Commonwealth Edison

April 18, 1984

Subject: Byron Generating Station Units 1 and 2
River Screenhouse Seismic Design
NRC Docket Nos. 50-454 and 50-455

This letter provides additional information regarding the seismic design basis for the river screenhouse at Byron Generating Station. NRC review of this information should help close Confirmatory Issue 1 of the Byron SER.

FIGURE Q362.1-1:

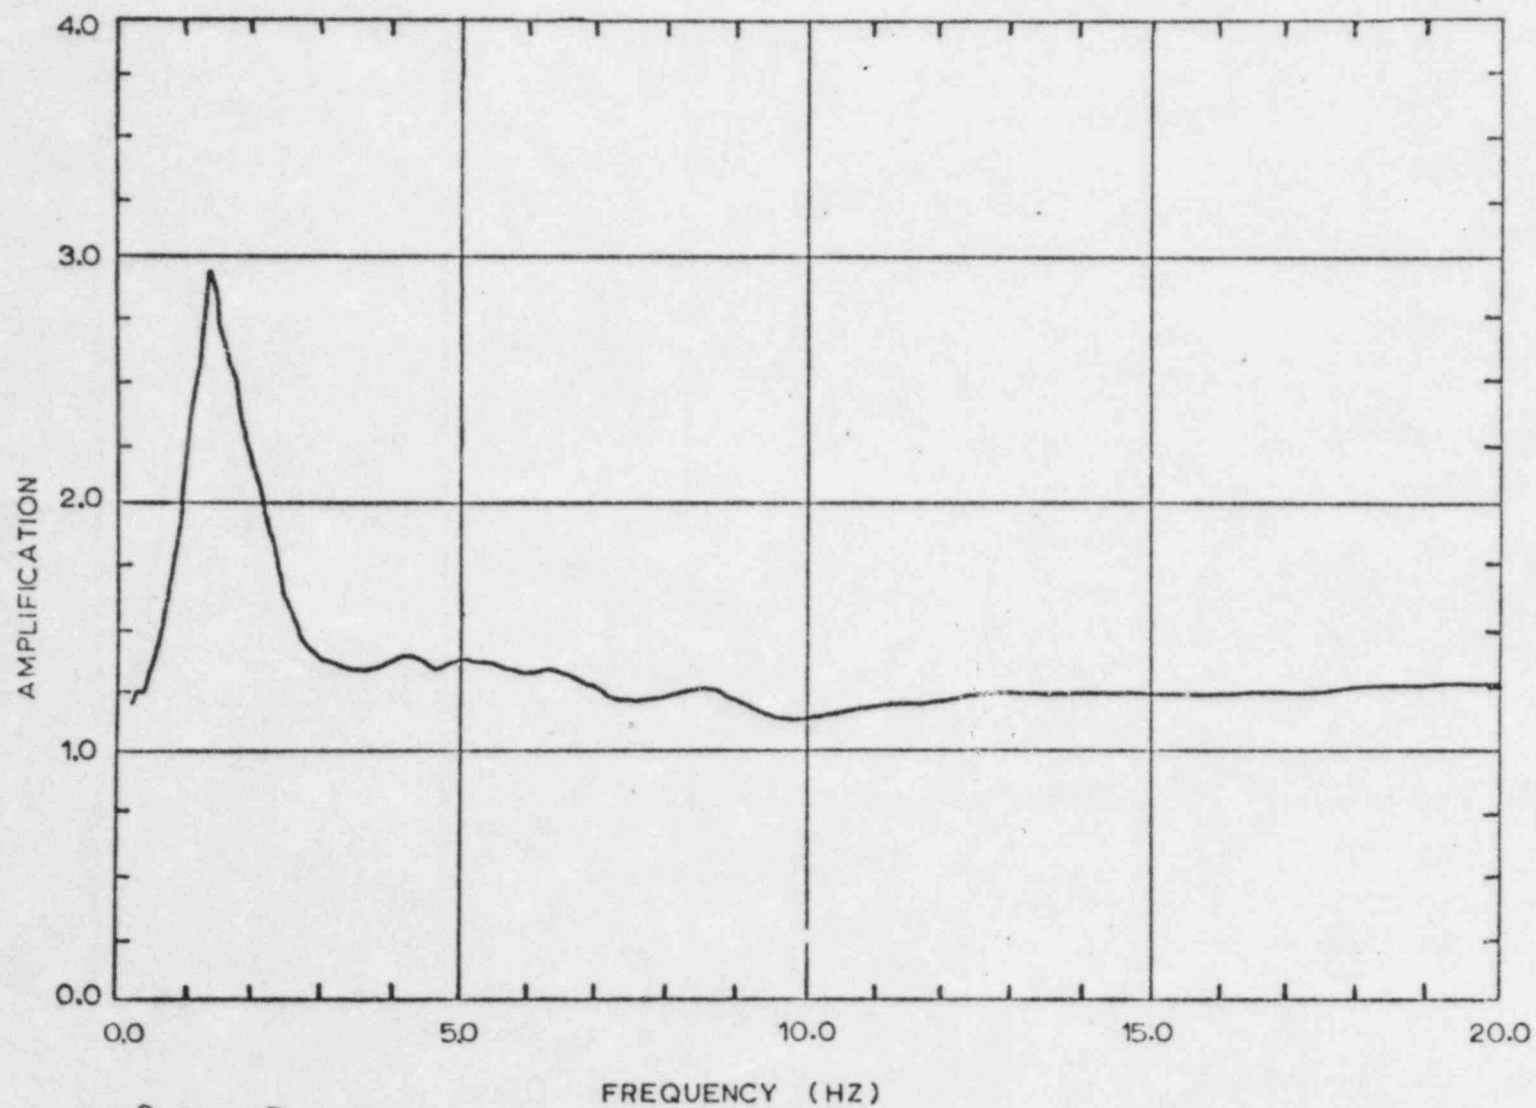
"The safe shutdown earthquake for the Byron Station site is based on the postulated occurrence of a maximum Modified Mercalli intensity VIII (body wave magnitude 5.8) earthquake near the site. (See Byron Station Safety Evaluation Report (SER), NUREG-0876). The staff's position as stated in the Byron Station SER is that a Regulatory Guide 1.60 response spectrum with a high frequency anchor of 0.20g at the foundation level of structures founded on rock is an adequately conservative representation of the vibratory ground motion from this size earthquake.

"Demonstrate the adequacy of the design basis for the river screen house by directly calculating a site-specific response spectrum and/or by calculating the amplification of an appropriate rock spectrum resulting from the presence of the soil.

There are two site specific spectra for $m_b = 5.8$ that are suitable for use in establishing the adequacy of the Byron river screen house design spectrum. One of these was generated by Illinois Power Company for the justification of the seismic design of the Clinton Power Plant (Reference 1) and the other was generated by LLL/TERA (NUREG/CR-1582) for use in the NRC-sponsored seismic hazard analysis program. Figure Q362.1-1 provides a comparison of the Clinton site specific spectra, LLL/TERA soil spectra and the Byron river screen house design basis time-history spectra. All spectra are plotted for a 5% oscillator damping. The Clinton and the LLL/TERA site specific spectra are the 84th percentile spectra for $m_b = 5.8$ earthquake and soil sites. Note that the Byron river screen house design spectrum is significantly higher than both the Clinton and the LLL/TERA spectra.

The geophysical average shear wave velocity at the Byron river screen house site is computed to be 935 to 1110 fps, compared to 2100 fps at Clinton. The soil depth at the Byron river screen house site is 90 feet, where as at Clinton it is approximately 180 feet. Thus, the soil column frequencies (based on $V_s/4H$ criteria) at the two sites are close to each other and based on the soil column frequency characteristics, one would expect the spectra at Byron river screen house to be similar to that at Clinton. The large margin inherent in the Byron river screen house design spectrum when compared to the Clinton site specific spectrum (Figure Q362.1-1) provides us with the

FIGURE Q241.8-1

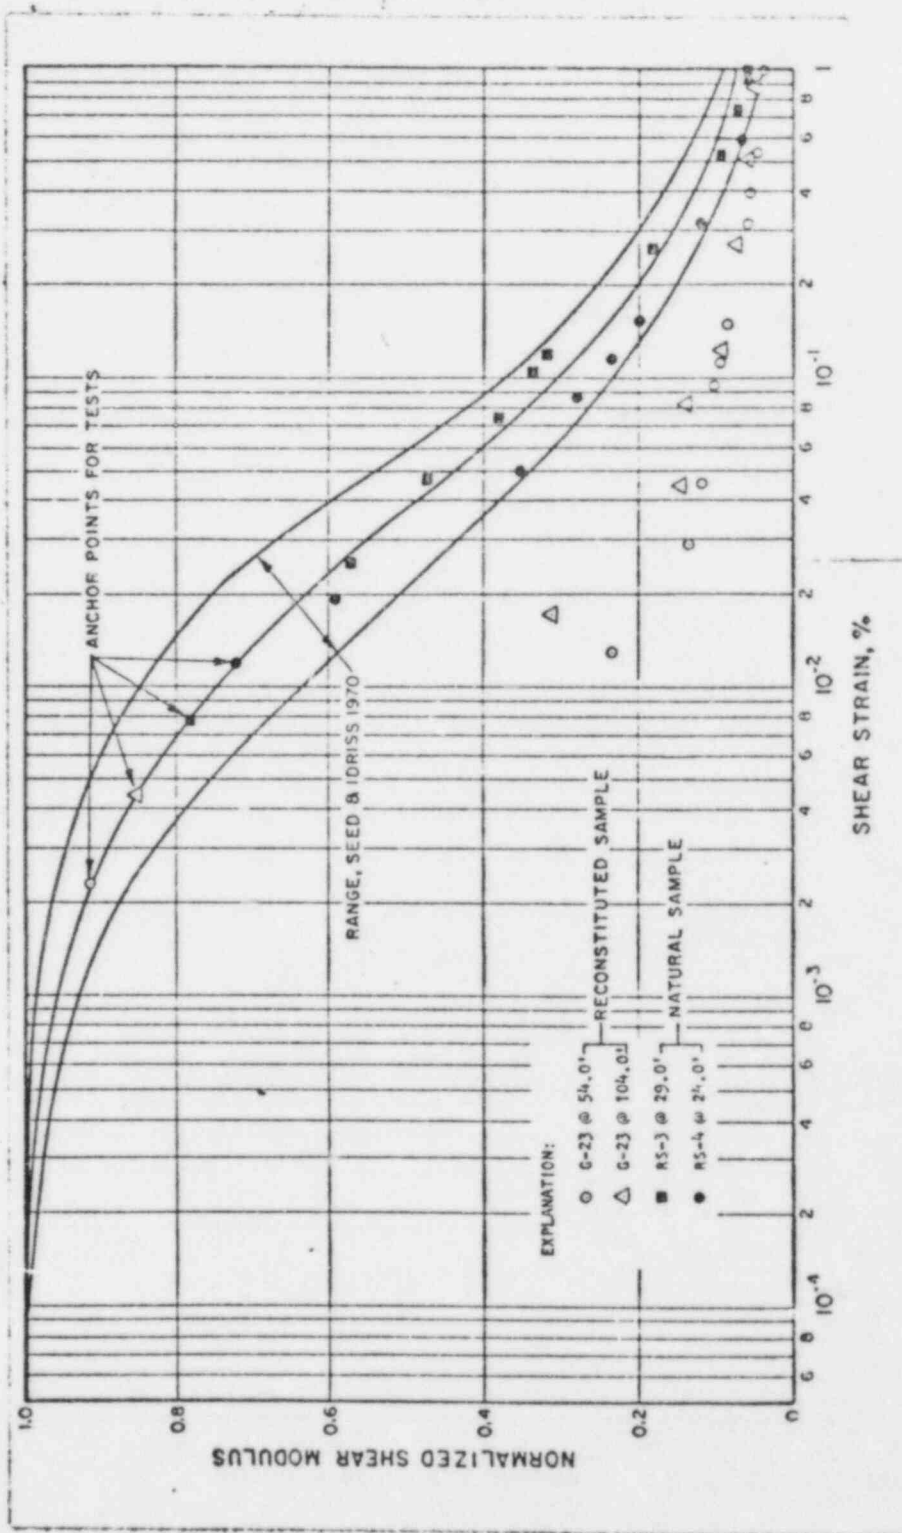
"To verify the seismic analyses of the river screen house foundation are sufficiently conservative at higher frequency range, perform a confirmatory seismic response analysis. The staff requires that the higher shear moduli values obtained from the laboratory tests (FSAR, Figure 2.5.89), i.e., the moduli of the reconstituted samples, be used in the analyses. To account for variability of the soil properties, the analyses using the upper bound shear moduli plus or minus 50 percent of their values should also be included. The response to this question is a necessary element of the response to Q362.1 because of the need for proper characterization of the soil conditions for a site specific spectrum or amplification calculation."

Figure Q241.8-1 shows the results of the cyclic triaxial tests on both intact and recompacted samples plotted in a normalized form. (It should be noted that the foundation for the river screen house was placed on natural soils, and that the river screen house, therefore, is not resting on recompacted material.) The points plotted on this figure were established by anchoring the shear modulus (G) at the lowest strain level obtained during the triaxial tests on the Seed and Idriss (Reference 5) normalized shear modulus (G/G_{\max}) strain degradation curve. By obtaining the normalized shear modulus value at this strain level, a G_{\max} value for the tests was obtained based on the mean Seed and Idriss (Reference 5) strain degradation curve for strains smaller than the minimum shear strain for the tests. The other data points were then normalized based on the obtained G_{\max} value.

The results of normalizing the test data show that the undisturbed samples exhibit strain degradation characteristics within the range postulated by Seed and Idriss (Reference 5); however, the recompacted soil samples follow strain degradation curves unreasonably steep compared to the normalized curve. We believe these characteristics are the result of the test procedures rather than actual soil properties. The tests on the recompacted samples, completed approximately 1 year prior to the tests on the intact samples, were performed on a machine that had been calibrated according to standard procedures, but not corrected for piston friction. A correction for piston friction is usually not necessary for property tests at high strain values, where high loads are required to obtain the desired deformation. At small strains, where smaller loads are required, the piston friction represents a significant portion of the recorded load. It should be
